# Errata Sheet

<b>Product Family:</b>	DL205 / DL305	<b>Date:</b>	September 2018
<b>Manual Number</b>	D2-DCM		
<b>Revision and Date</b>	2nd Edition; February 2003

Page A-4. Point-to-Point RS422 D2–DCM as Master

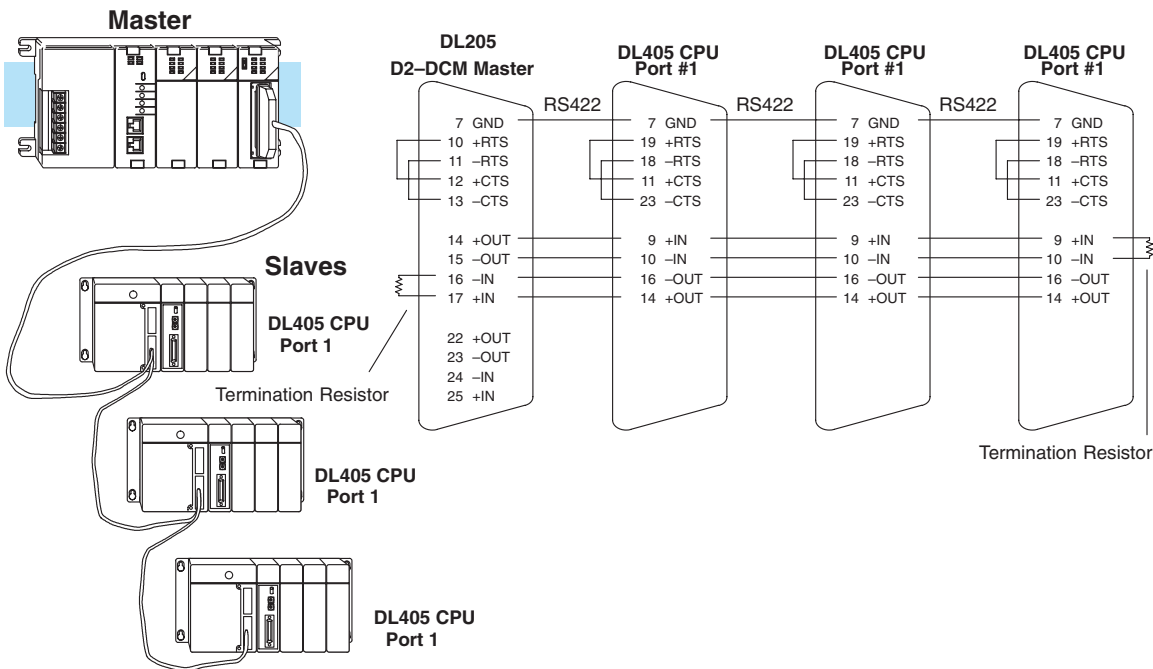
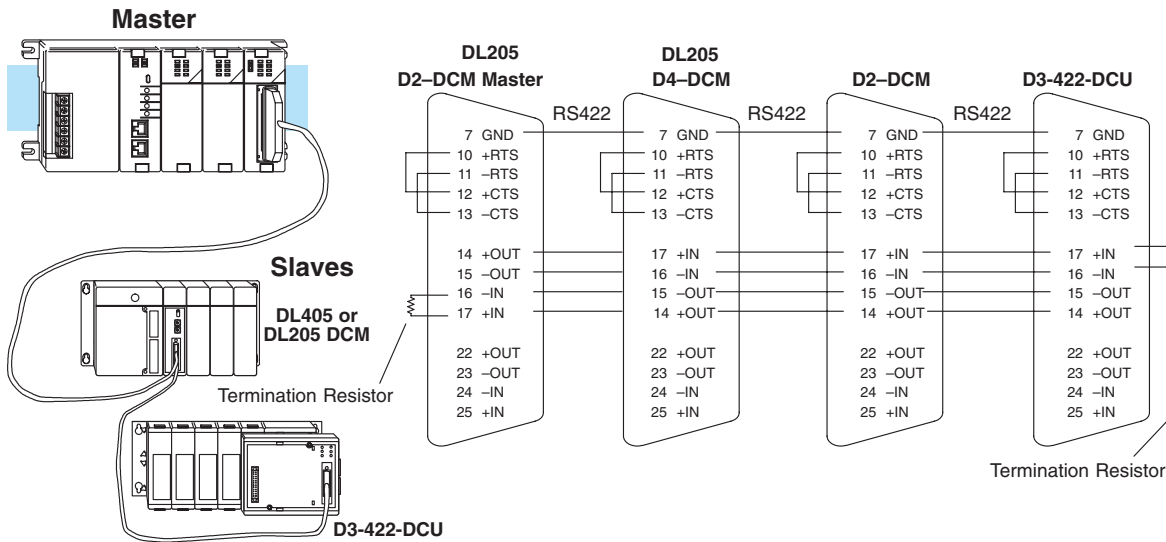
In the lower left drawing there are some pin number errors for the DL405 port 1 25-pin connector. The correct pin numbers are:

19 +RTS (not 10 as shown)

18 -RTS (not 11 as shown)

11 +CTS (not 12 as shown)

23 -CTS (not 13 as shown)

In the top set of drawings, change the callout that says “DL405 CPU Bottom Port” to DL405 Port 1”

# Install the D2-DCM and Starting the Network

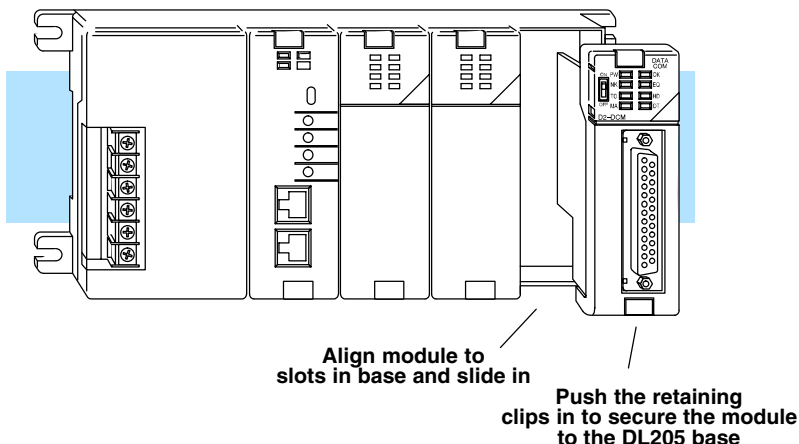
*D3-DCM cannot be mounted in the farthest slot from the CPU in a base. It requires 300 mA of +9 V base power. Make sure you will not exceed the available base power budget by installing the D3-DCM.*

*D3-DCM cannot be mounted in the farthest slot from the CPU in a base. It requires 300 mA of +9 V base power. Make sure you will not exceed the available base power budget by installing the D3-DCM. See the DL305 User Manual for complete details on power budget calculations."*
